# SAFETY ALERT

## NTI Boiler Safety Alert

### **FTG SERIES BOILERS**

February 13th, 2026  
**FTG Safety Advisory – Mandatory Upgrade**

Part No. 6501412000 – FTG Upgrade Kit Contents:

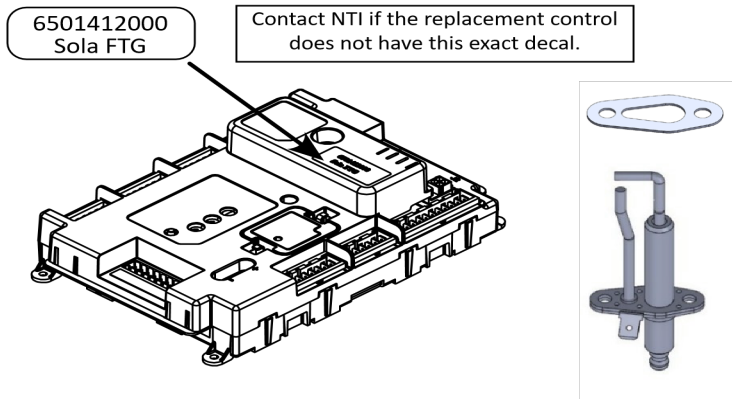
- Replacement Sola control PCB (+ return label)
- New ignition electrode w/ gasket (+ 2x screws)

**Note:** Due to the potential safety concern, the old control *and* electrode **MUST** be returned to NTI using the return label provided. The boiler's S/N (embedded in the label) will be flagged until the control is received.

### **STEP 2 — Replace ignition electrode**

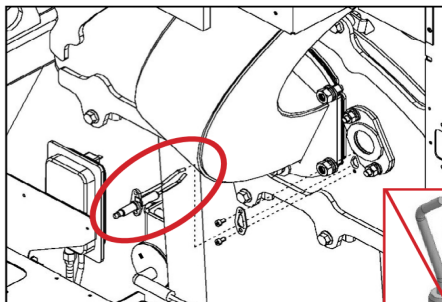
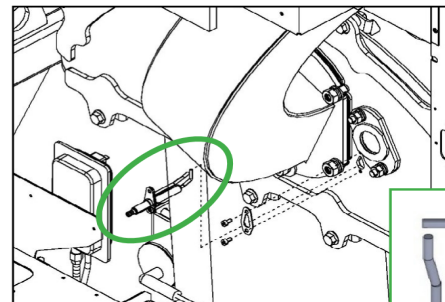
Longer ceramic insulation for better spark characteristics

Failure to replace the ignition electrode with the new electrode illustrated above may increase the risk of delayed ignition.

- 1** Remove existing electrode (2 T20 screws) and discard gasket

- 2** Install new electrode with new gasket (2 T20 screws)

### 2 Modulation Rate Adjustment

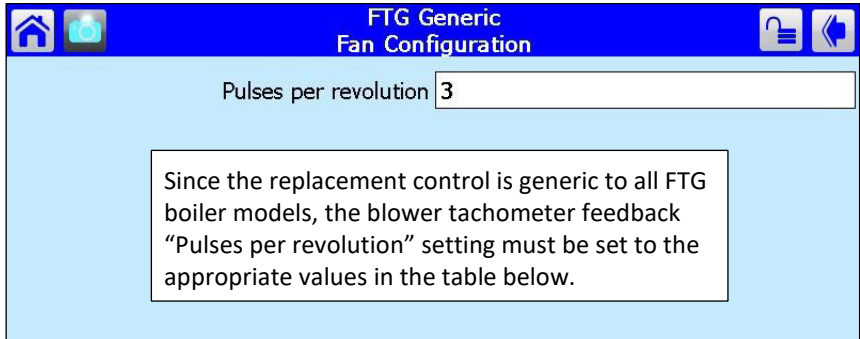
Since the replacement control is generic to all FTG series boiler models, the minimum and maximum modulation rates must be set to the applicable values in the table below.

Parameter	Description	Settings (rpm)						
		FTG600	FTG800	FTG1200	FTG1400	FTG2000	FTG2200	FTG2400
CH max. modulation rate	Maximum permissible blower speed during CH demand. Setting is model dependent.	5600	7450	8100	7800	7100	7200	8000
DHW max. modulation rate	Maximum permissible blower speed during DHW demand. Setting is model dependent.	5600	7450	8100	7800	7100	7200	8000
Minimum modulation rate	Minimum permissible blower speed. Setting is model dependent.	1150	1150	1050	1050	1050	1050	1050
